Bayside Planning Panel

Item No	6.6
Application Type	Development Application
Application Number	DA-2017/307
Lodgement Date	23 March 2017
Property	28 Alfred Street, Ramsgate Beach
Owner	Ramsgate Beach Pty Ltd
Applicant	Space 0.618:1
Proposal	Construction of a two (2) storey attached dual occupancy development, including rooftop terrace, front fence, demolition of existing structures and Torrens title subdivision creating two lots
No. of Submissions	Three (3) submissions
Cost of Development	\$ 625,000.00
Report by	Adam Iskander, Development Assessment Planner

Planning Assessment Report

Application Number:	DA-2017/307
Date of Receipt:	23 March 2017
Property:	28 Alfred Street, RAMSGATE BEACH (Lot X DP 390114)
Owner:	Ramsgate Beach Pty Ltd
Applicant:	Space 0.618:1
Proposal:	Construction of a two (2) storey attached dual occupancy development, including rooftop terrace, front fence, demolition of existing structures and Torrens title subdivision creating two lots
Recommendation:	Approved
No. of submissions:	Three (3)
Author:	Adam Iskander
Date of Report:	13 February 2018

2 21st JUNE 9AM SHADOWS
Scale 1:200

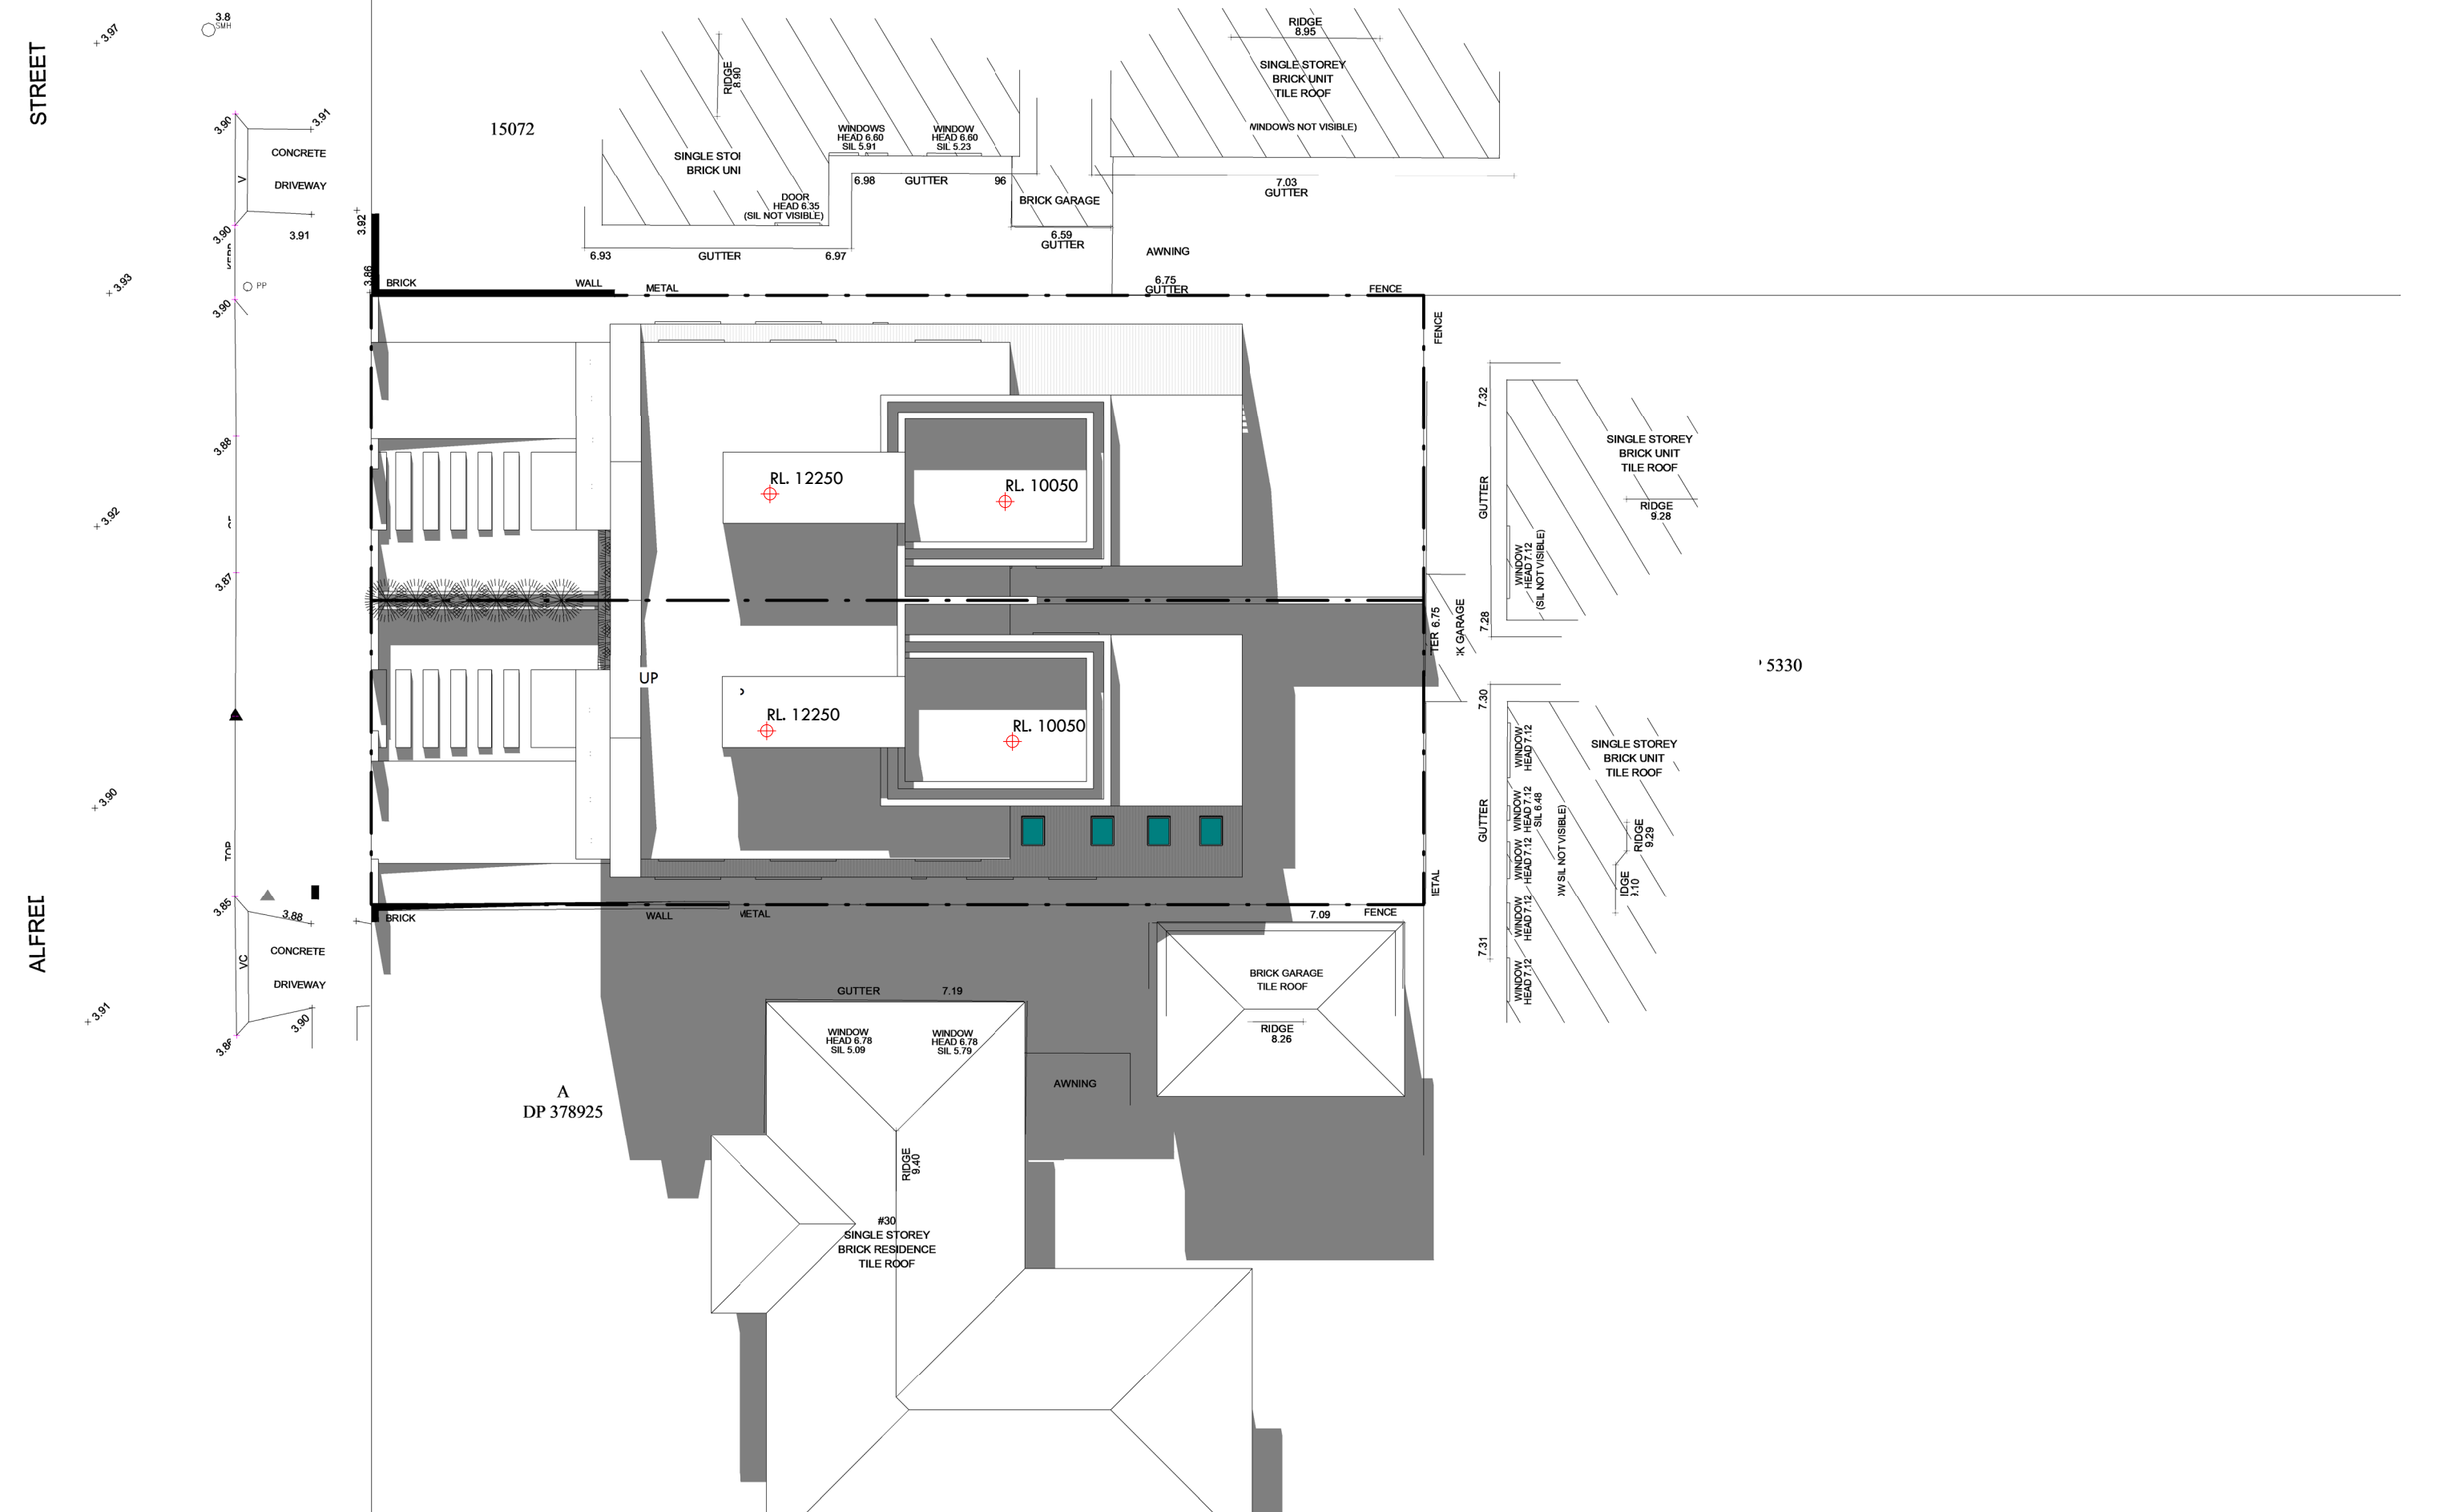
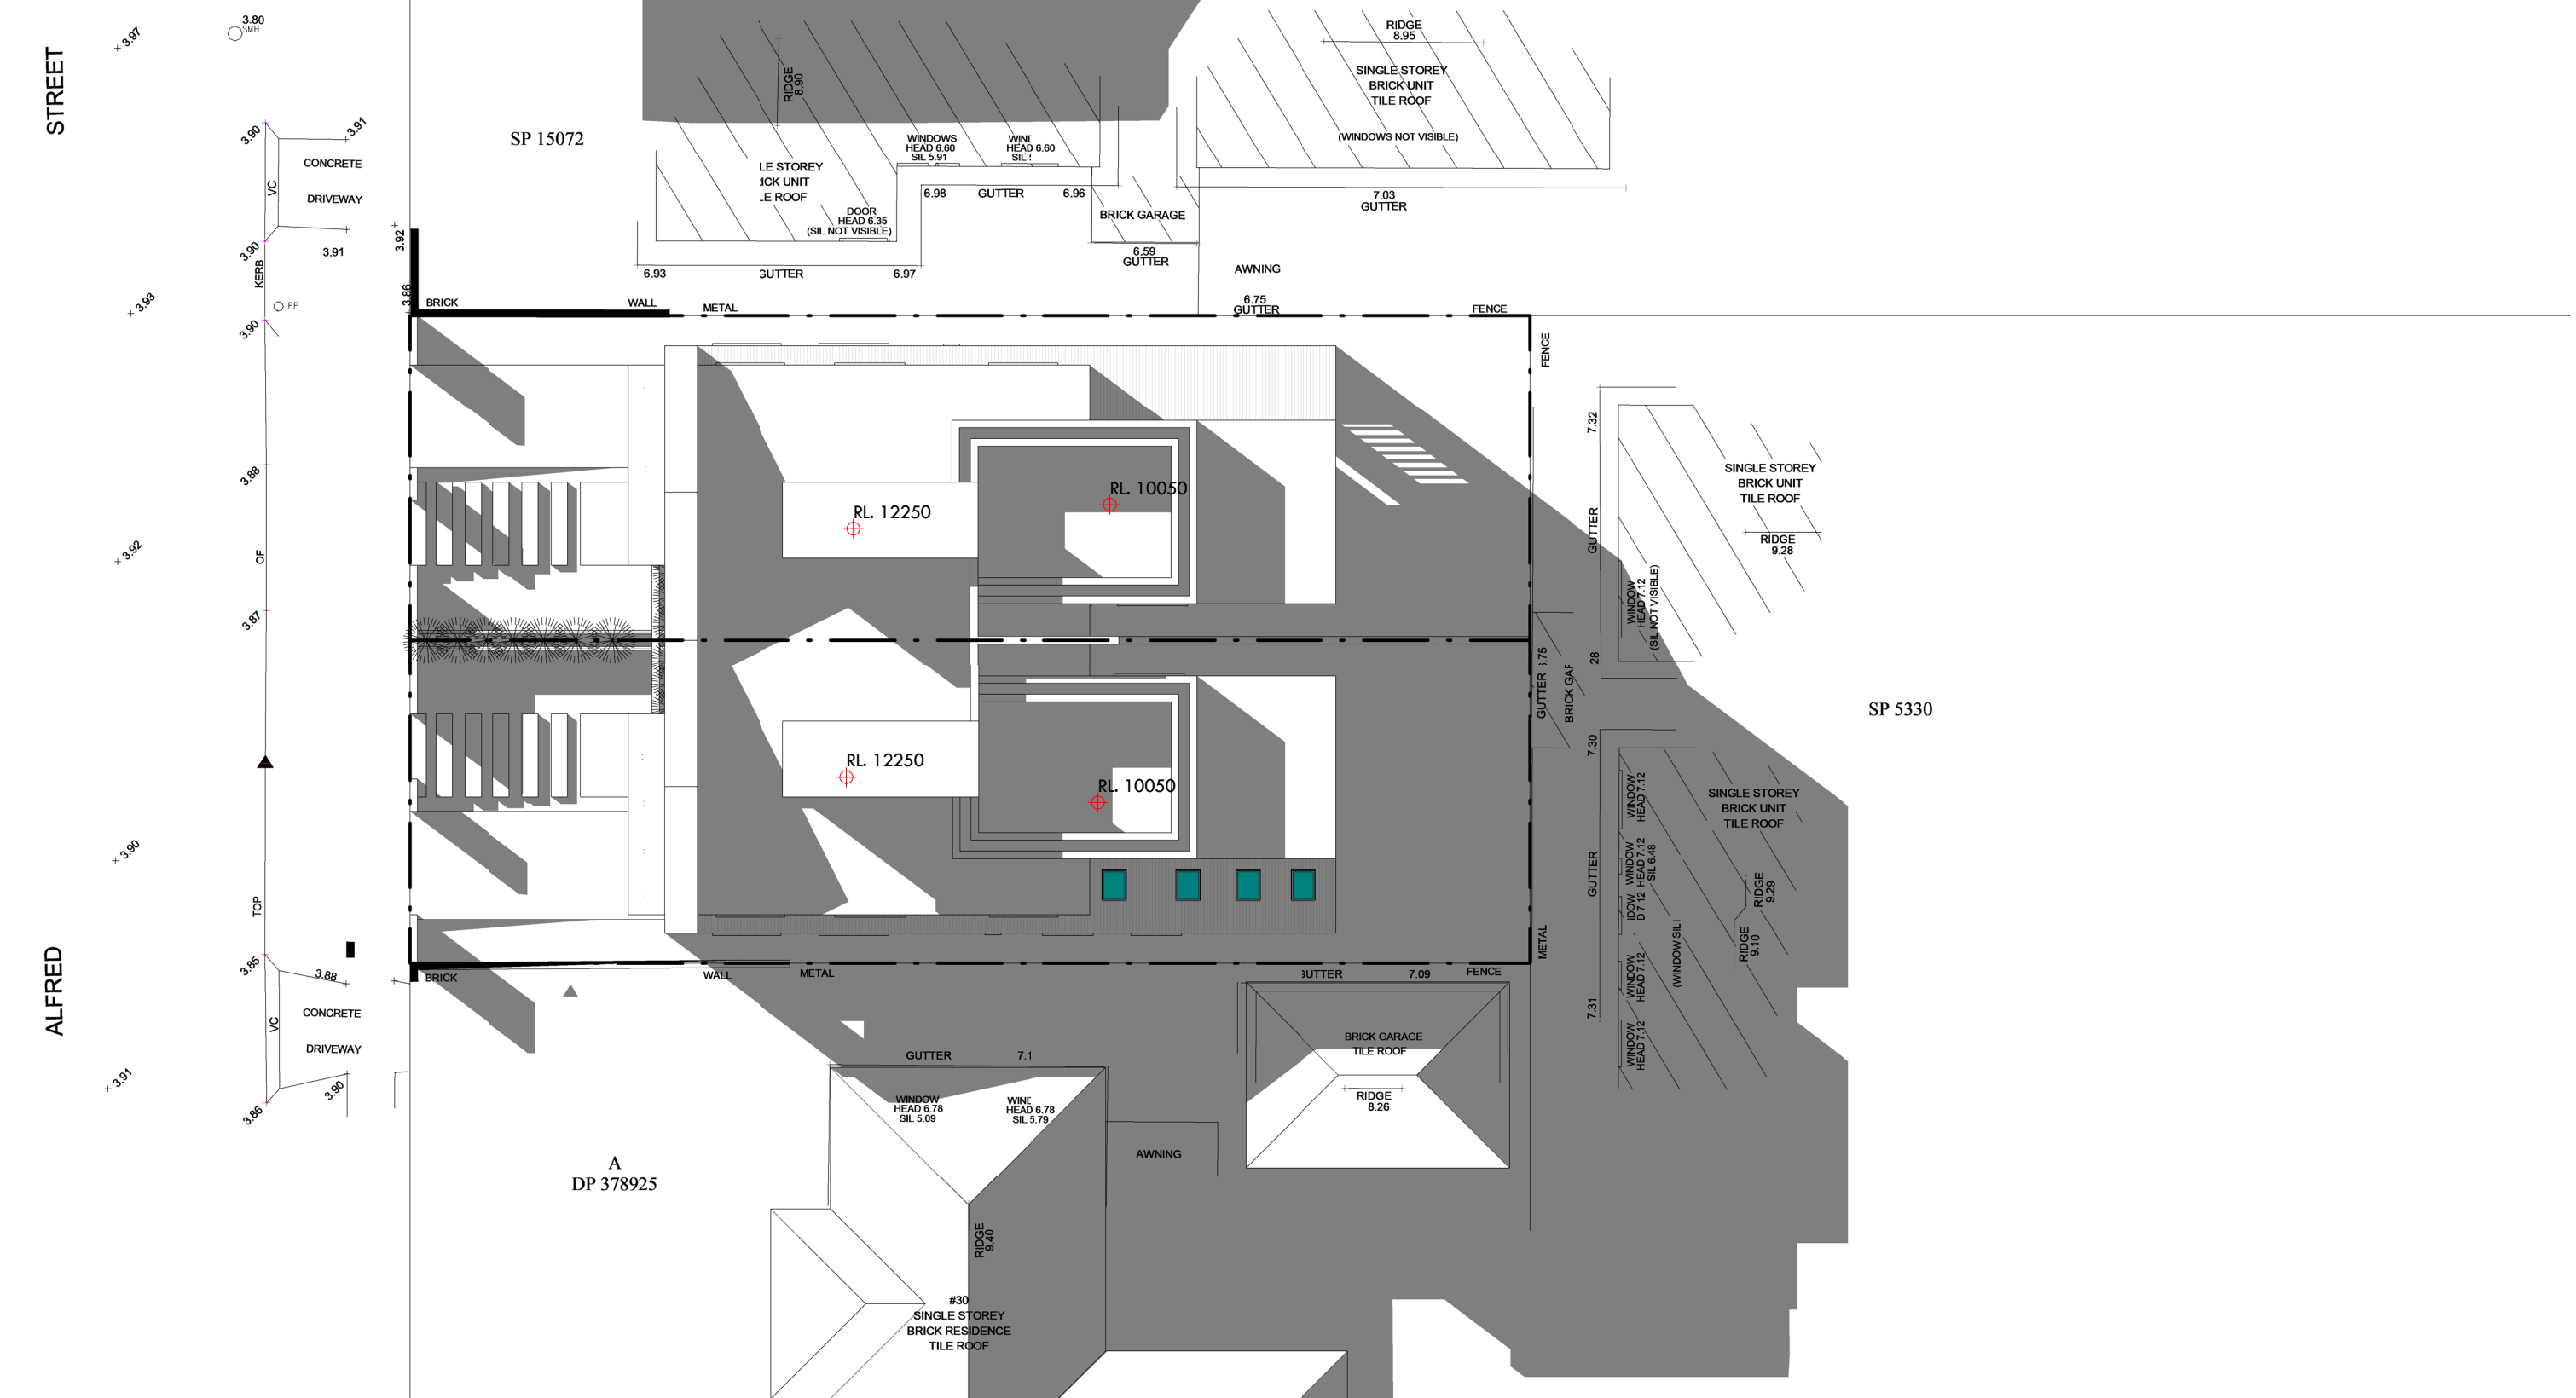
The adjoining dwelling to the south is situated on a property that has an east-west orientation. The applicant has submitted shadow diagrams for 9 a.m., 12 p.m. and 3 p.m. on June 21. The shadow diagrams show that the adjoining windows will not receive the prescribed amount of sunlight, however at least 50% of the private open space will receive sunlight.

The 3D scale shadow diagrams show that at 9am entire yard and rear windows of the adjoining southern neighbour will receive solar access and the front facing windows of the dwelling will receive solar access at 3pm.
